# OICA comments on GTR21

EVE-IWG #67

09.01.2024

OICA proposal to modify 6.9.2.1. according to COP tolerance

### COP data analysis:

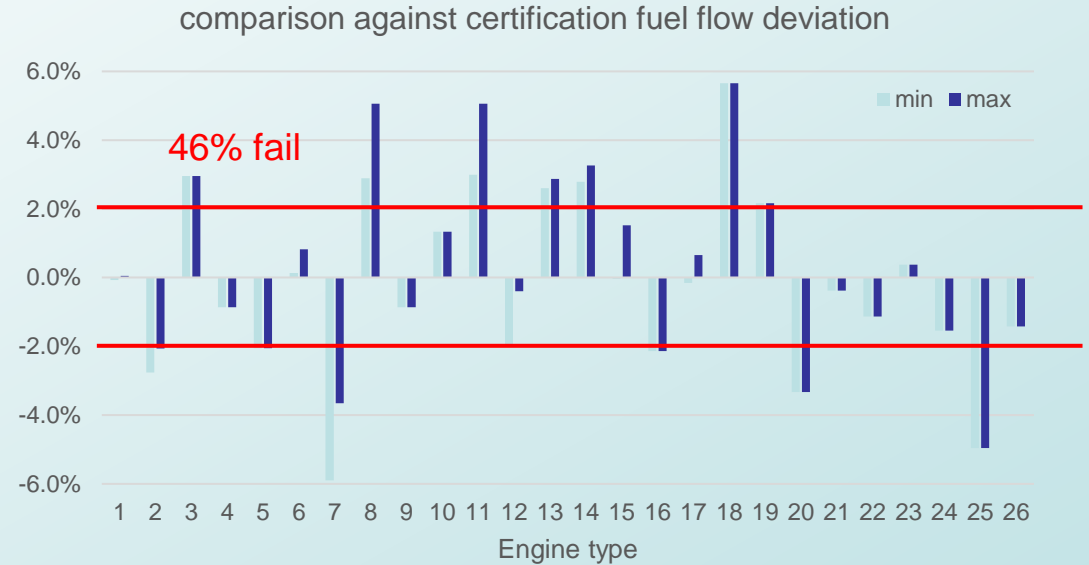
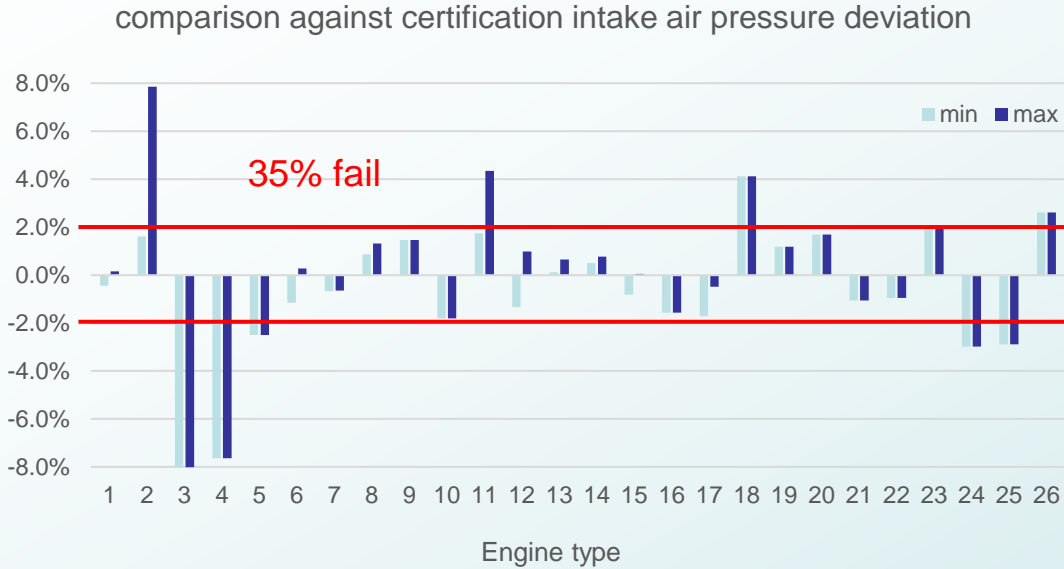
- ACEA conducted an analysis of 26 COP tests on R85
- The test results are real life data and had to be strictly anonymised before sharing
  - Intake air pressure deviation: **35% fail (@ 2%)**
  - Fuel flow deviation: **46% fail (@ 2%)**
- EVE-IWG acknowledged, that GTR21 TP1 measurement requires a higher measurement tolerance than R85

**OICA requires to set the tolerance in 6.9.2.1. to +- 5%**
